AN ORDINANCE approving Change Order No. 8 Contract No. 77-W-2, in connection with the Filtration Plant Addition.

RE: City of Fort Wayne, IN
Water Works Improvements
Filtration Plant Additions
Contract 77-W-2

CHANGE ORDER NO. 8 DATE: April 14, 1980

BULLETIN NO 8

McNAMEE, PORTER AND SEELEY CONSULTING ENGINEERS ANN ARBOR, MICHIGAN		FORT WAYNE, INDIANA WATER WORKS IMPROVEMENTS FILTRATION PLANT ADDITIONS	CONTRACT 77-W-2
SCALE AS NOTED	DATE 2-12-80	PIPE SUPPORTS EXISTING NORTH GALLERY	SHEET SS-8 OF
DRAWN HAN	CHECKED JPO

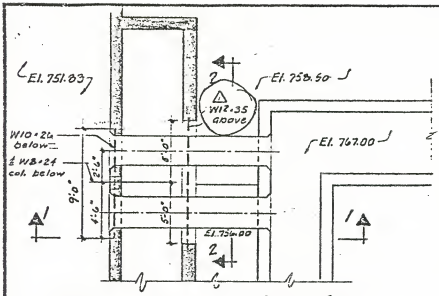
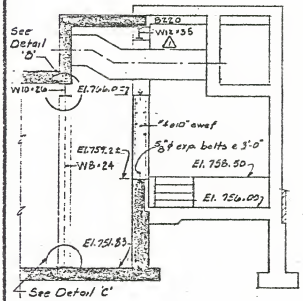
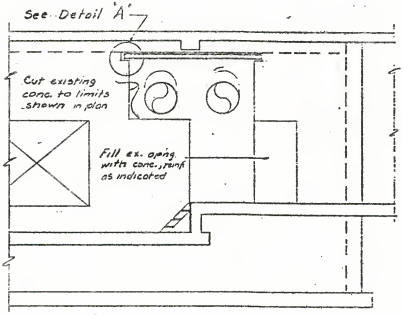
2. The opening into the existing North Gallery at the two 30-inch bypass lines is revised. Provide structural steel supports as detailed on Supplemental Sheet SS-8 which is being issued with this Bulletin. Also see Letter 2/15, and see Letter 2/26

It is necessary to revise supplemental drawing SS-8 issued with Bulletin No. 8 issued February 12, 1980.

The steel beam at the north wall of the existing north gallery should be W12X35 rather than W10X35 as shown on the drawing. This also changes a demolition dimension in Detail A.

△Revised 2/15/80 Issued with Bull #8

McNAMEE, PORTER AND SEELEY CONSULTING ENGINEERS ANN ARBOR, MICHIGAN		FORT WAYNE, INDIANA WATER WORKS IMPROVEMENTS FILTRATION PLANT ADDITIONS PIPE SUPPORTS EXISTING NORTH GALLERY	CONTRACT 77-W-2
SCALE AS NOTED	DATE 2-12-80		SHEET SS-8 OF
DRAWN HAN	CHECKED JPO

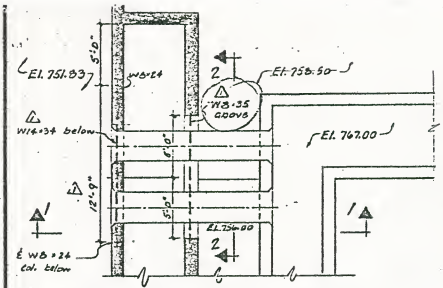
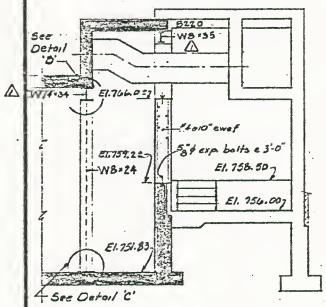
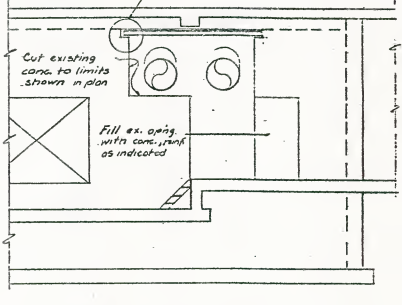
It is necessary to revise supplemental drawing SS-8 issued with Bulletin No. 8, February 12, 1980. Please note this drawing was also revised and reissued February 15, 1980. The attached drawings include the earlier revisions. Copies of that drawing should be destroyed.

△ Revised 2/22/80
